NOTICE OF DECISION

**CLASS 3 SITE PLAN REVIEW / CLASS 2 ADJUSTMENT / CLASS 1 DESIGN
REVIEW CASE NO.: SPR-ADJ-DR20-30**

SUMMARY: A proposal for a new 28-unit multi-family complex.

LOCATION: 4072 Market St NE, Salem OR 97301

SDR3

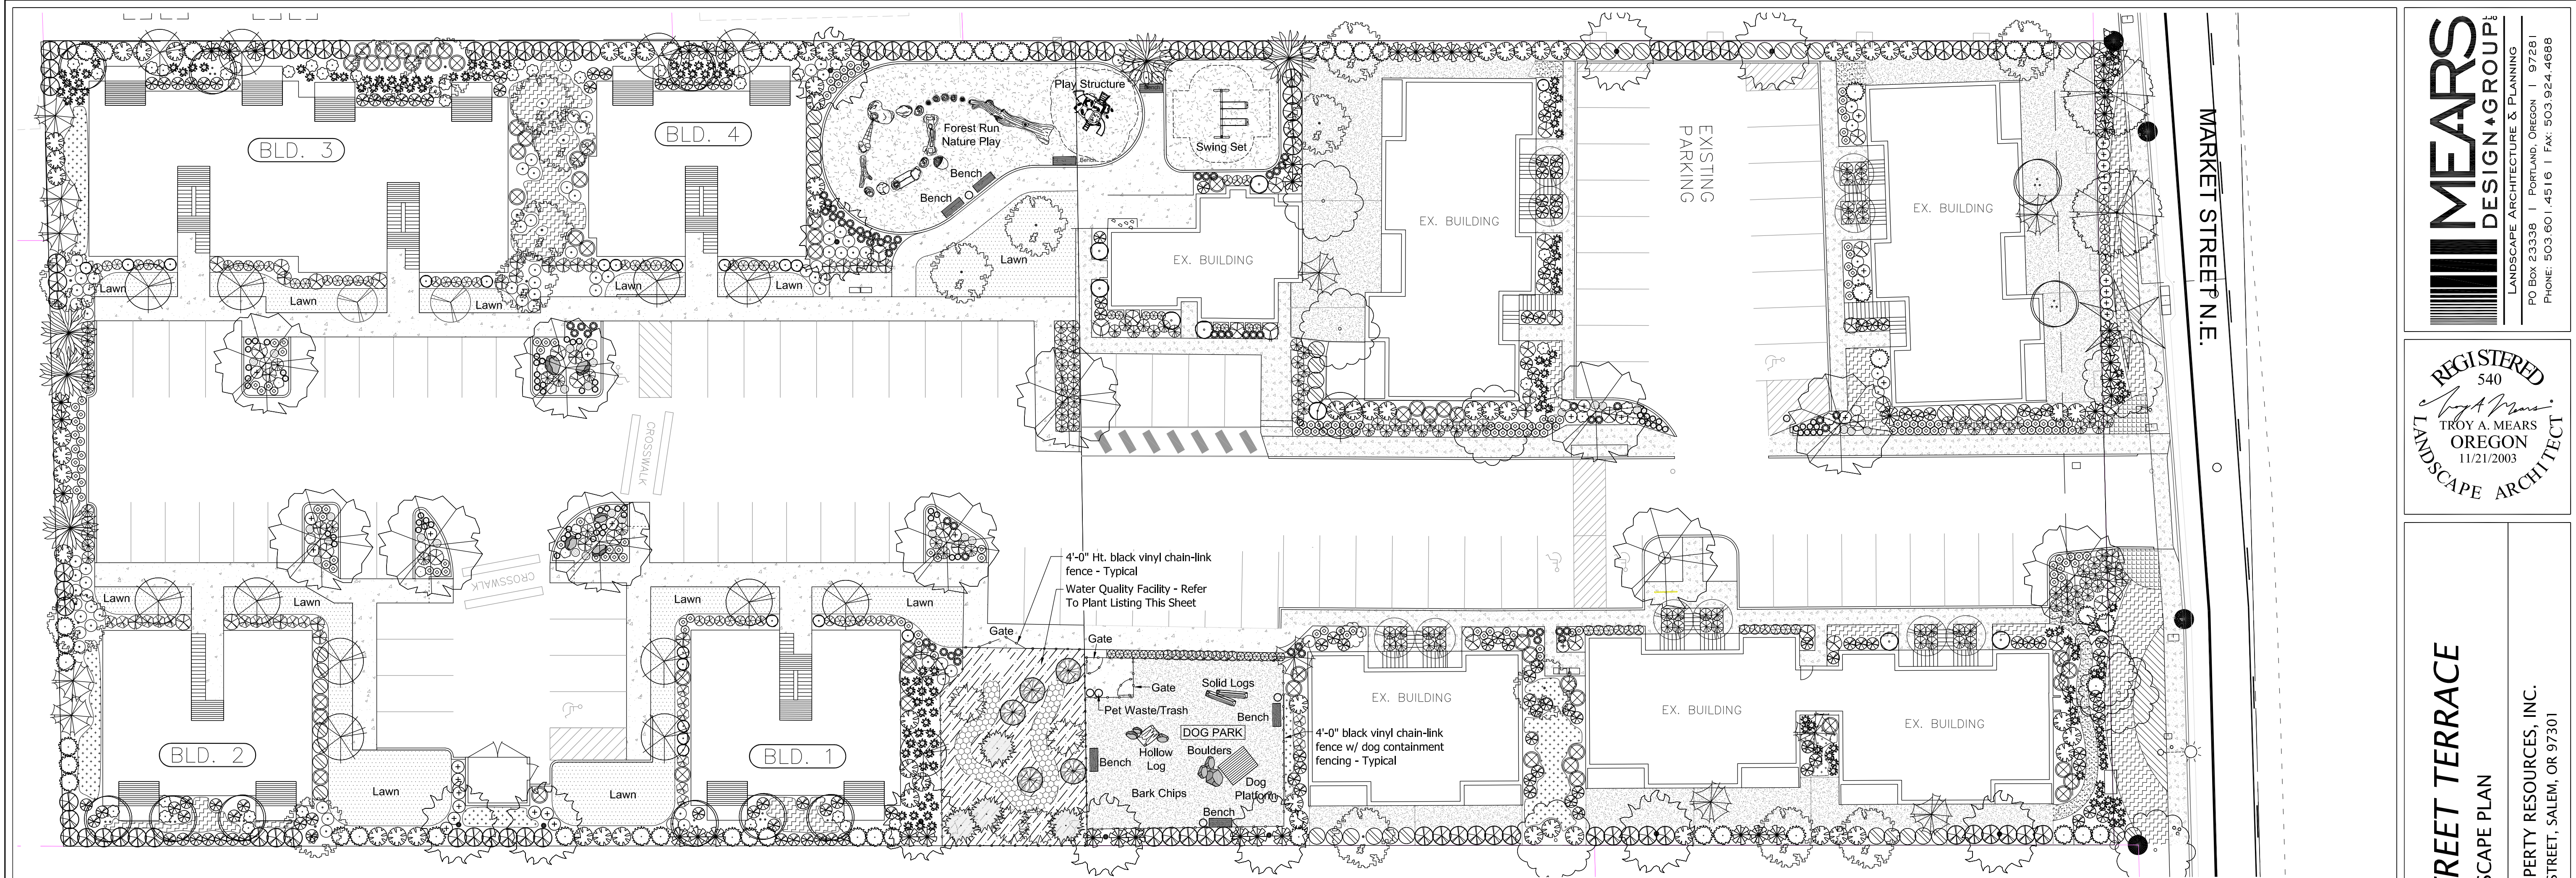
Finding: The floor plans provided indicate a window in each habitable room and on each wall overlooking common open space, parking areas and pedestrian paths. The applicant has not provided a lighting plan. The site plan indicates four pedestrian pedestal lights along the northern portion of the property, but do not extend south. The buildings each have exterior lights, but do not appear to have any at the entrances. The written statement indicates that exterior lighting will be provided on the buildings, at dwelling entrances and along pedestrian paths. To ensure the standard is met the following applies:

There site plan indicates fences along the exterior property lines, which are not sight-obscuring. These fences along the perimeter are required to be sight-obscured, as conditioned above.

Finding: The proposal does include parking, and the site plan shows sidewalks from the parking area to each building, between buildings, and connecting to the common open space and to Market Street through a neighboring property. The applicant's site plan and landscaping plan differ in pedestrian access to the northern property connecting to Market Street. The sidewalk provided along the northern property line, as conditioned, shall be provided and shall not cross the backside of any parking spaces. In addition, any location where the pedestrian connection crosses a driveway, the driveway shall be hatched and be protected by speed bumps on either side.

Condition 1: Lighting Plan with lighting along all portions of sidewalks, at each building entrance and on sides of buildings facing open space.

- Condition 1:** Lighting Plan with lighting along all portions of sidewalks, at each building entrance and on sides of buildings facing open space.
- Condition 2:** The pedestrian path from Building 4 and open space shall be provided to Market Street without crossing behind parking spaces on the adjoining property.
